re: **Grading and Site Servicing Plan Review**
Proposed Self Storage Development
75 Michael Cowpland Drive – Ottawa, Ontario

file: PG3798-MEMO.02 Revision 3

Site Servicing Plan Review

Grading Plan Review

Figure 1 - Proposed Thickened Edge Slab Foundation Insulation Detail

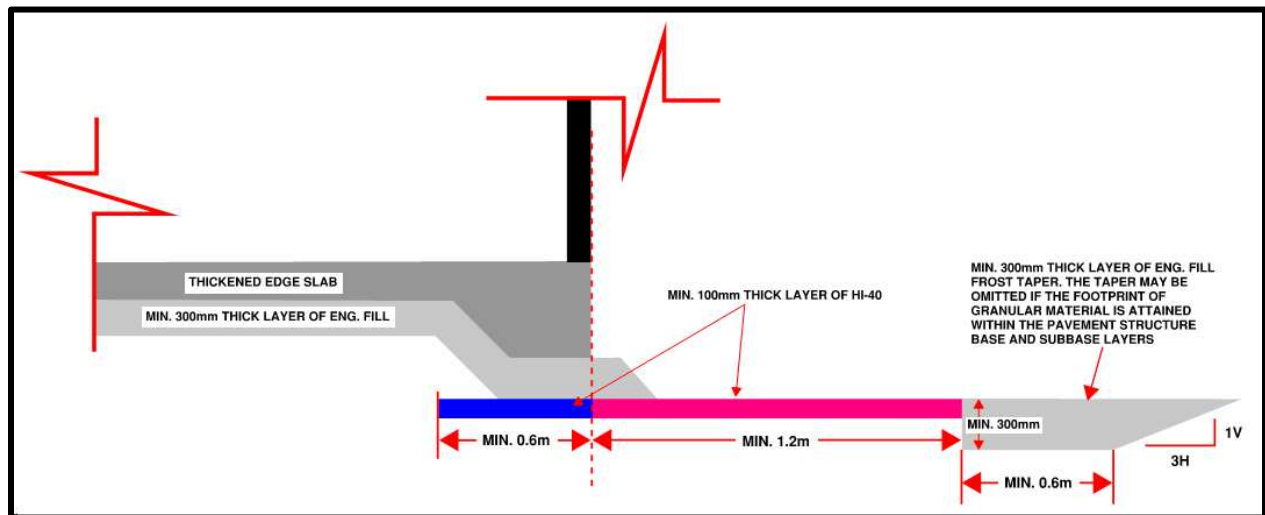
Due to the anticipated depth and proximity of the proposed service pipes to the proposed thickened edge slab footprints, it is expected the lateral support zones for the proposed structures will be negatively impacted by the service installation works. Further, future maintenance that could be considered throughout the proposed service alignments would require trenches that would impact the proposed buildings lateral support zones. Based on this, it is recommended to lower the lateral support zones for thickened edge footings located adjacent to impacting service alignments. This may be accomplished by sub-excavating a near-vertical trench located directly below the overlying footing footprint and in-filled with minimum 17 MPa lean-concrete.

It is recommended the near-vertical trenches extend a minimum of 150 mm horizontally beyond the overlying footing footprint. Based on our review, the lean-concrete trench detail has been incorporated satisfactorily into the above-noted site servicing plans. The recommended perimeter thickened-edge slab foundation insulation detail is depicted below for the proposed storage structures and has been incorporated satisfactorily in the above-noted site servicing plans. The placement of the lean-concrete trench and rigid insulation should be reviewed and approved by Paterson personnel at the time of construction.

SHEET TITLE
GENERAL PLAN OF SERVICES

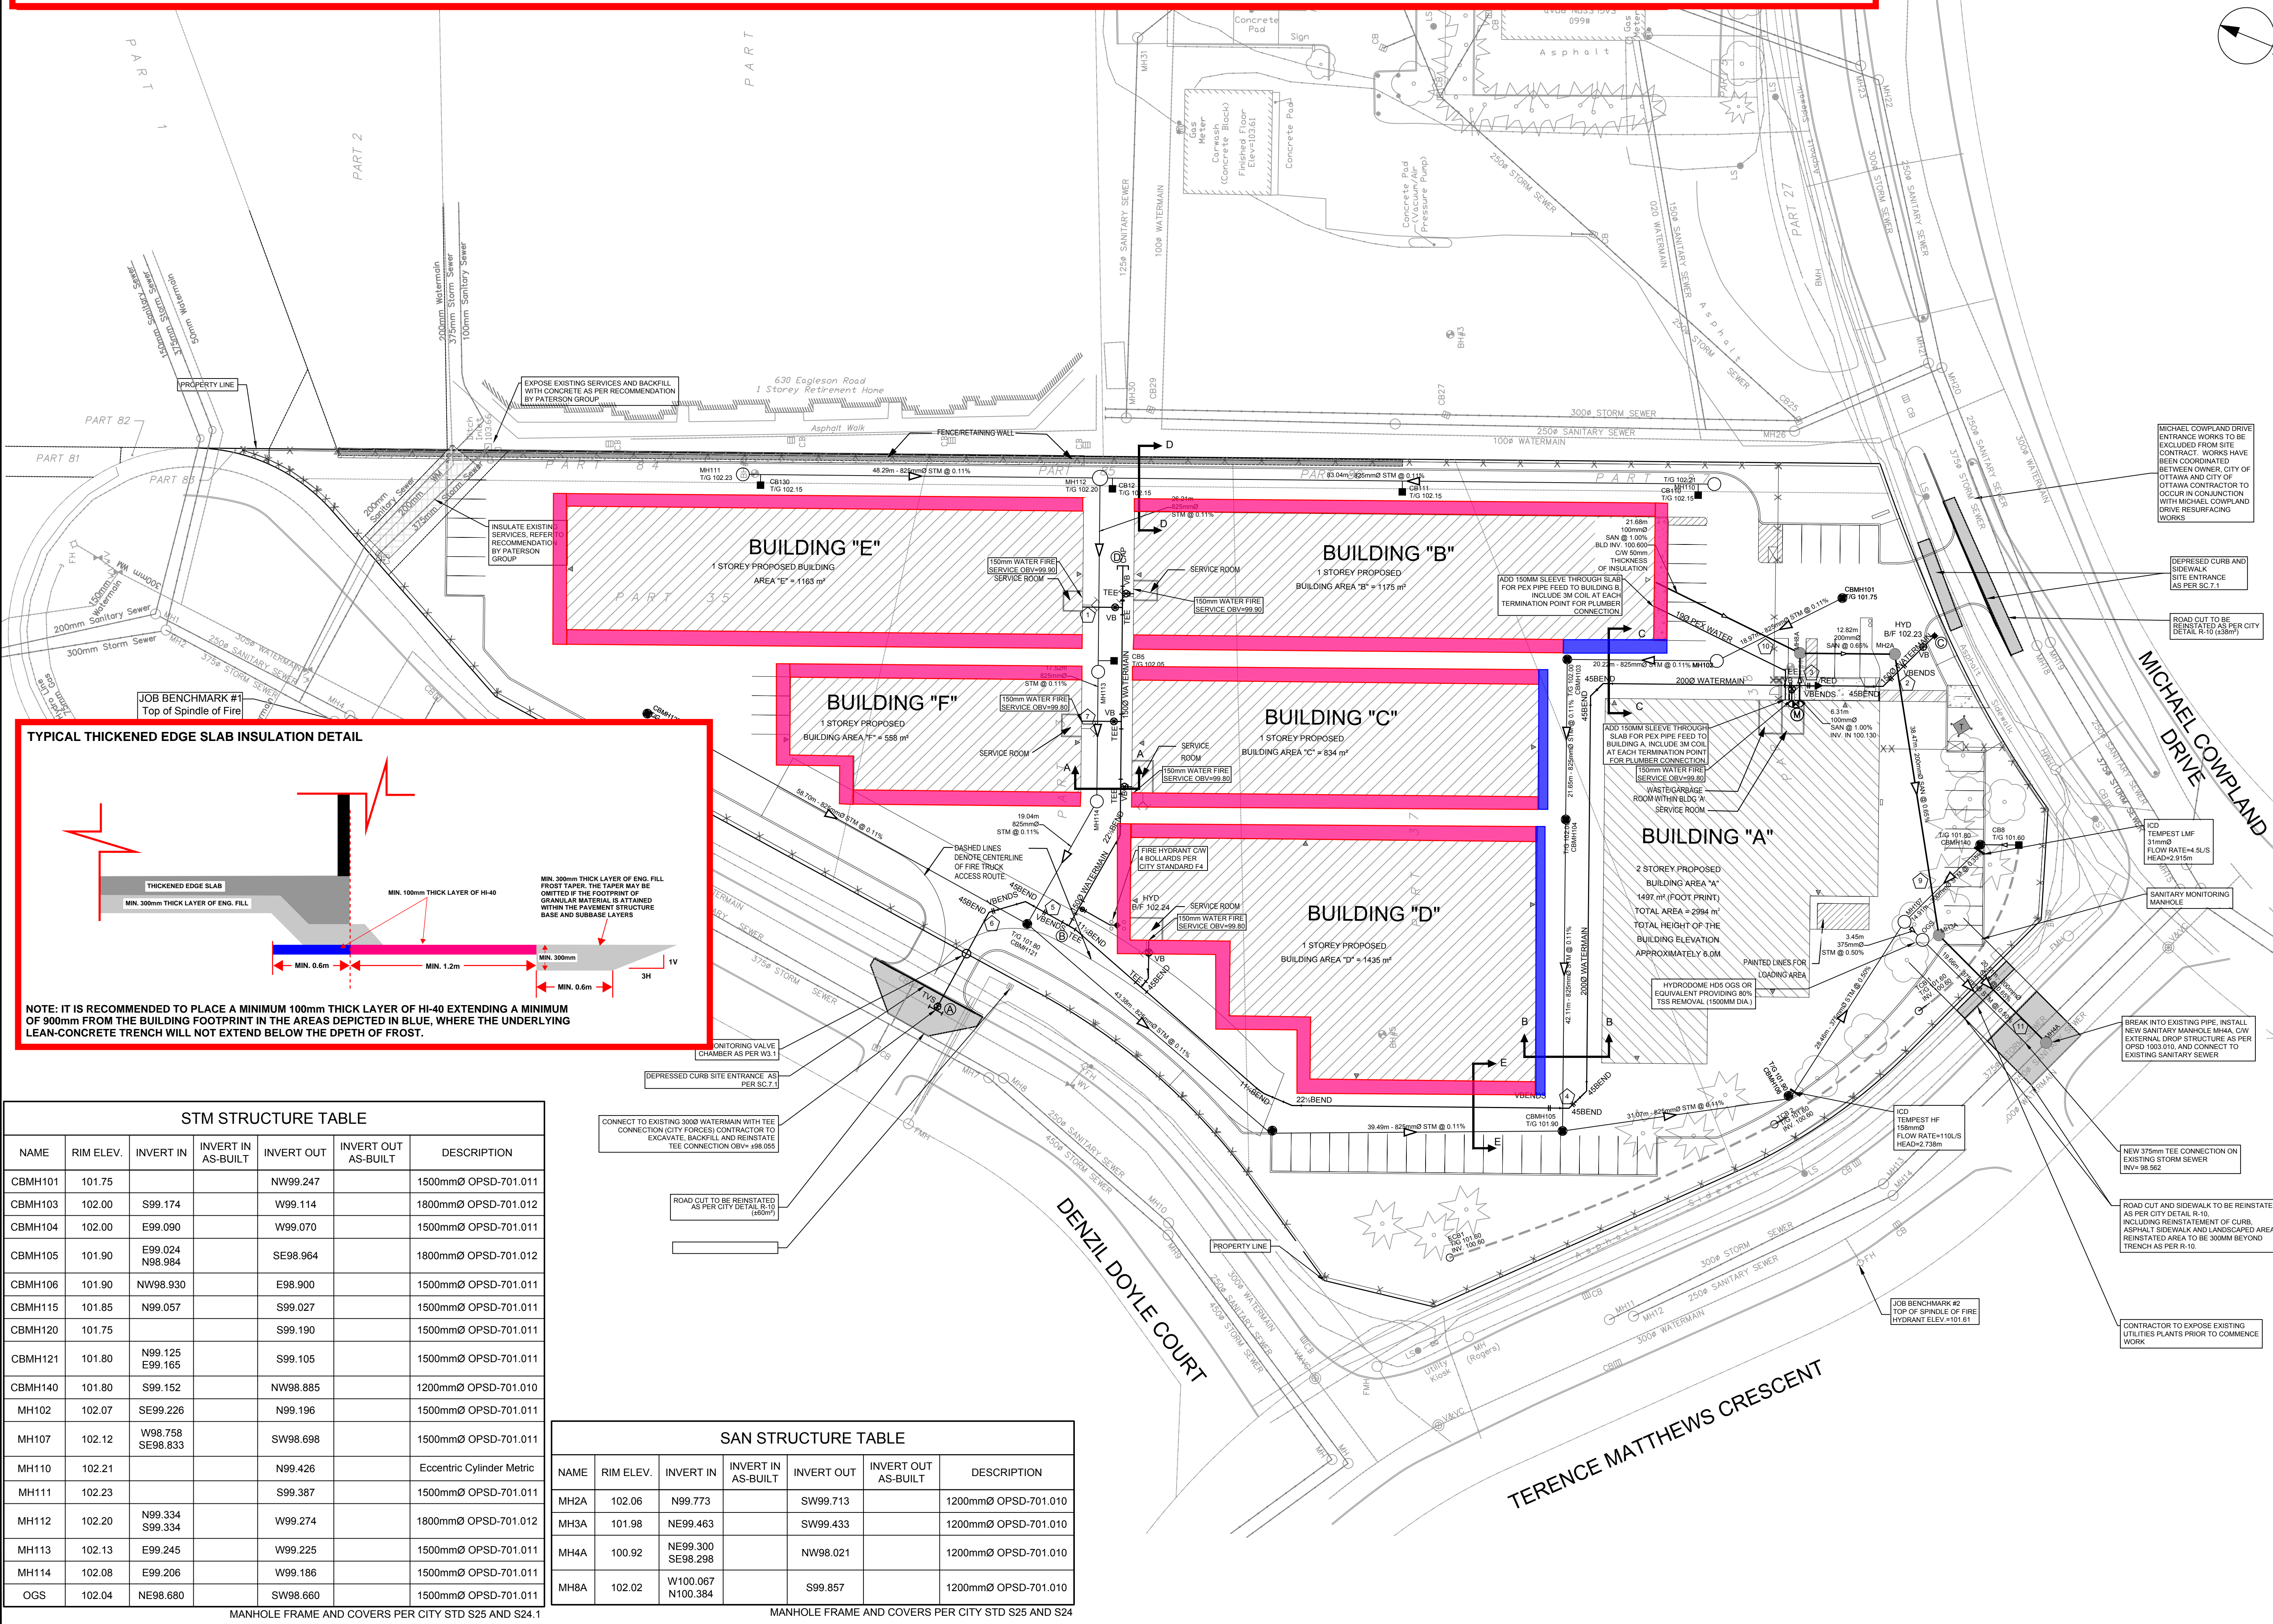
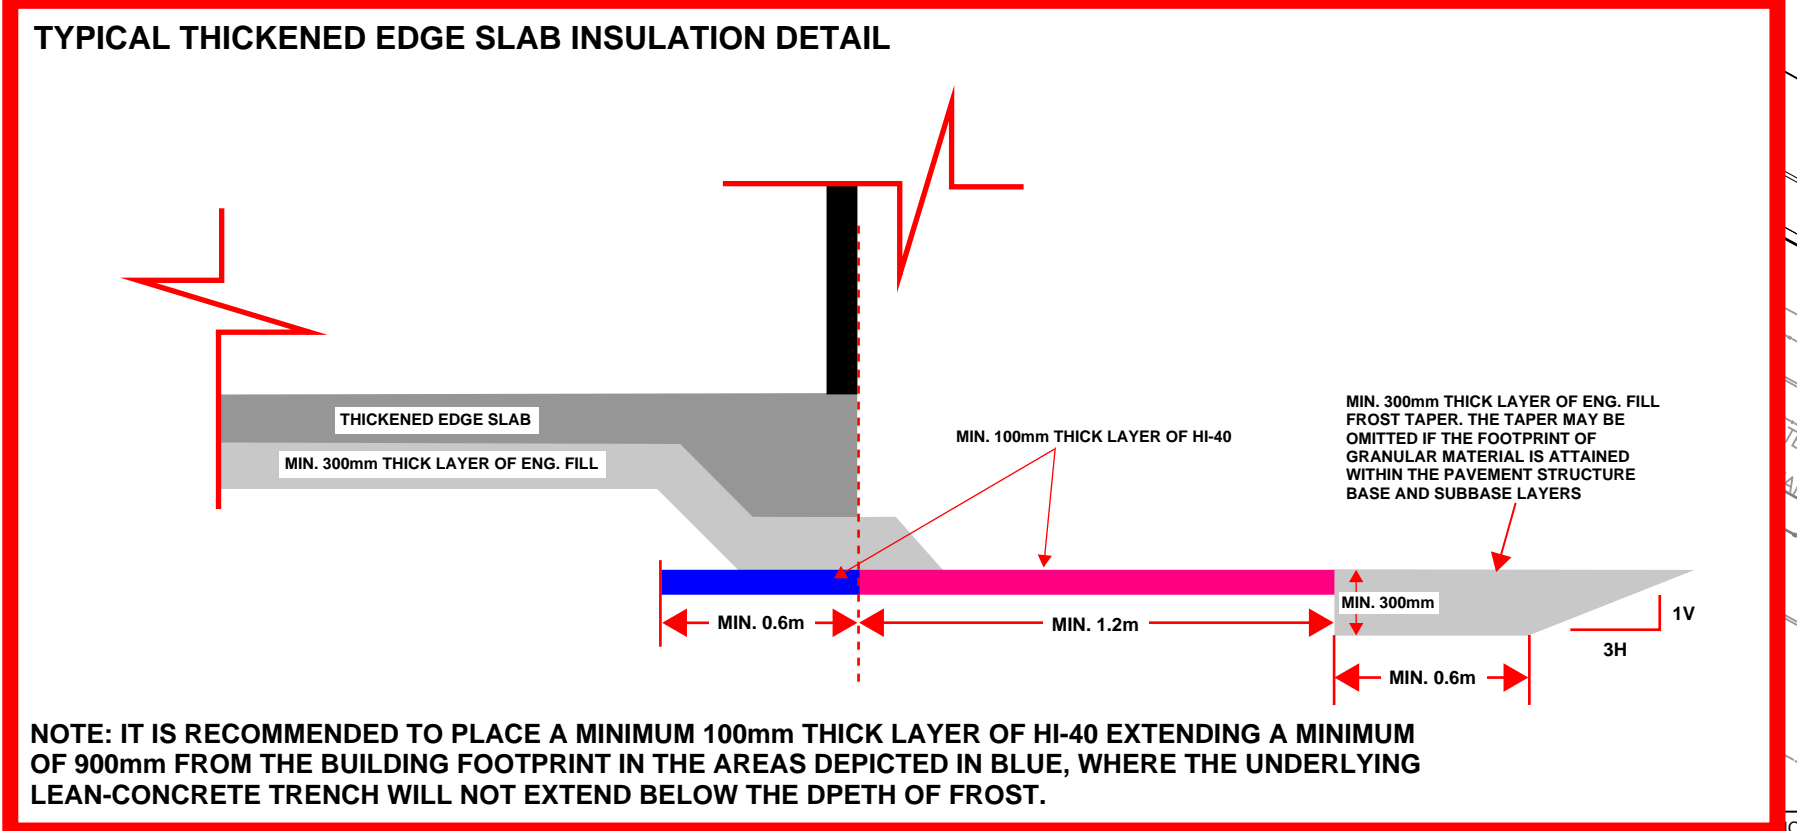
Based on our review of the above noted site service plans, the majority of the design details are considered to be acceptable from a geotechnical perspective. All proposed service pipes are sufficiently covered by adequate soil cover with no frost protection required.

Upon discussions with the design team, the proposed thickened edge slabs are now proposed to be placed on vertical, concrete in-filled trenches where adjacent service pipes are proposed with the lateral support zone of the proposed structures. These trenches would lower the lateral support zone of the slabs below the service trenches ensuring that the proposed buildings are protected should future excavation be required for the proposed services for maintenance purposes.
